**RE: Bronco Utah Operations LLC
Emery Mine
DOGM Permit No. C/015/0015
Emery 2 Subsidence Monitoring Plan Revision**

Title: e2 Phase II Subsidence Monitoring Plan Revision

Revise subsidence monitoring plan and update monitoring point locations

PLATE V-5
SUBSIDENCE MONITORING POINTS AND BUFFER ZONES

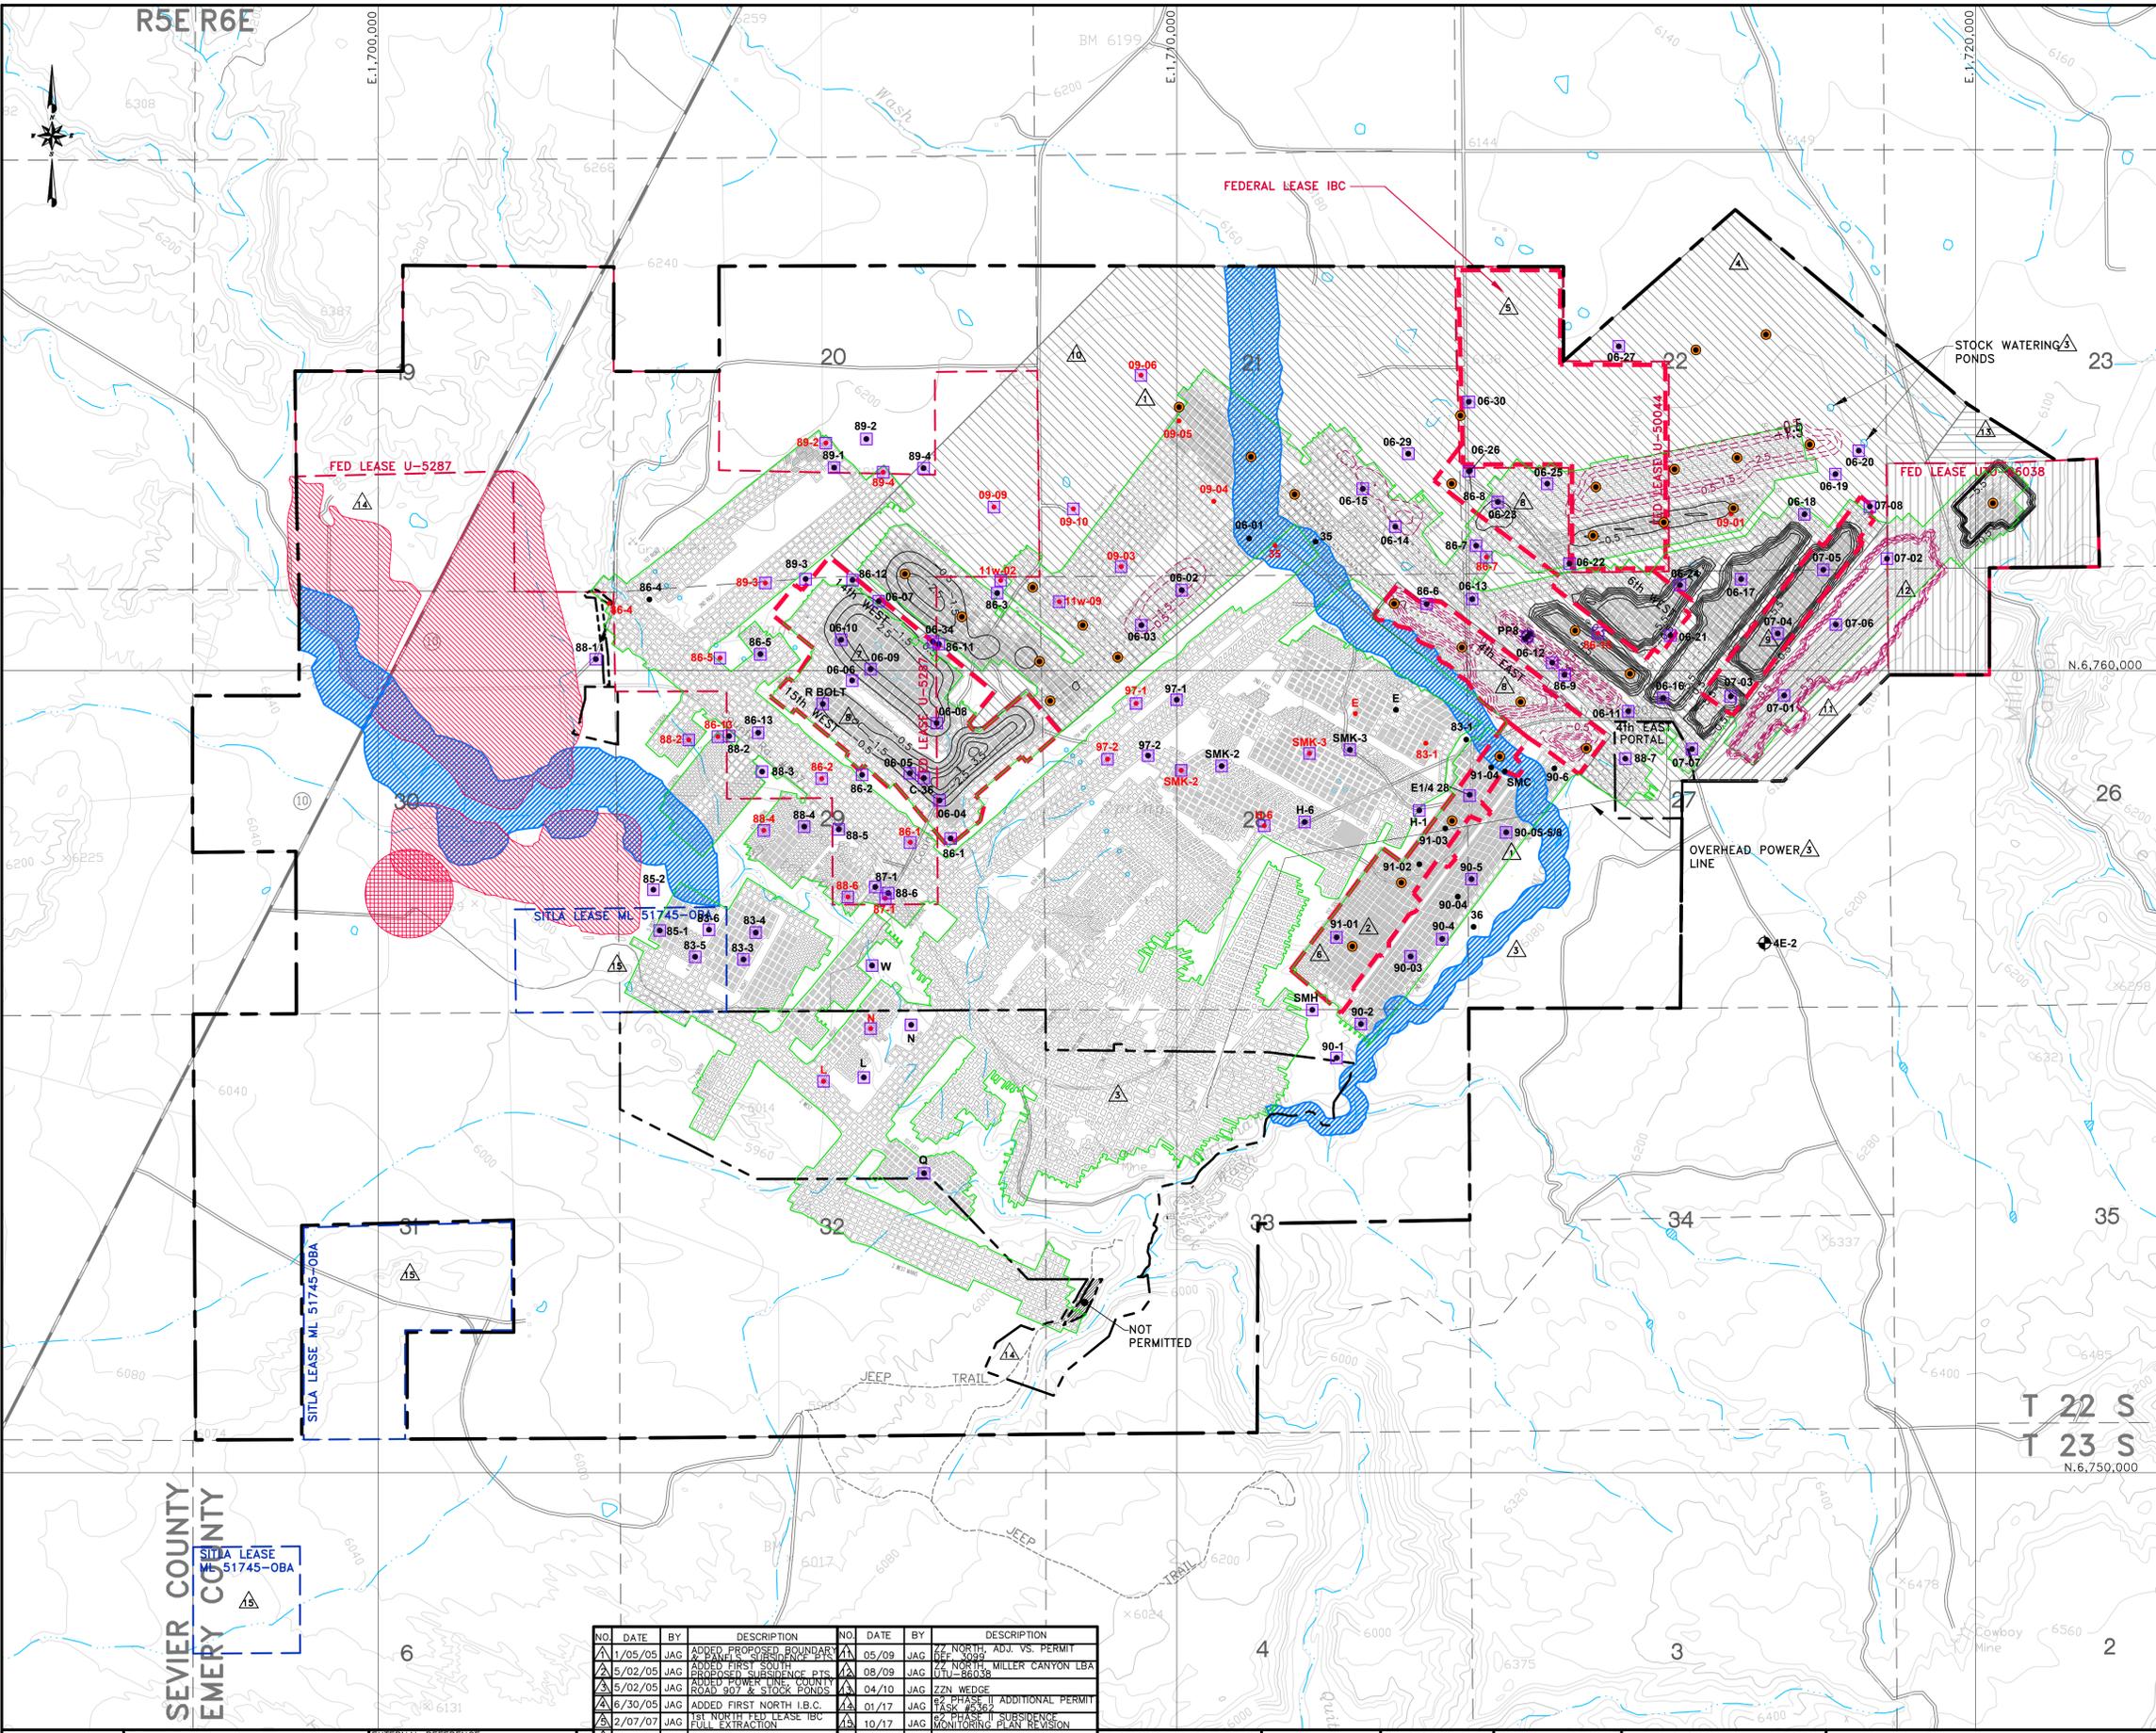
This submittal updates and revises the subsidence monitoring plan as well as Plate V-5 depicting the proposed and existing subsidence monitoring points. Several historical monitoring points were adjusted on the map to reflect their actual field surveyed locations. The proposed subsidence monitoring points that were not set will be removed from the map.

After historical review of the subsidence survey data included in the annual report, Bronco is proposing to discontinue monitoring of the points that have not experienced movement over the past 10 years.
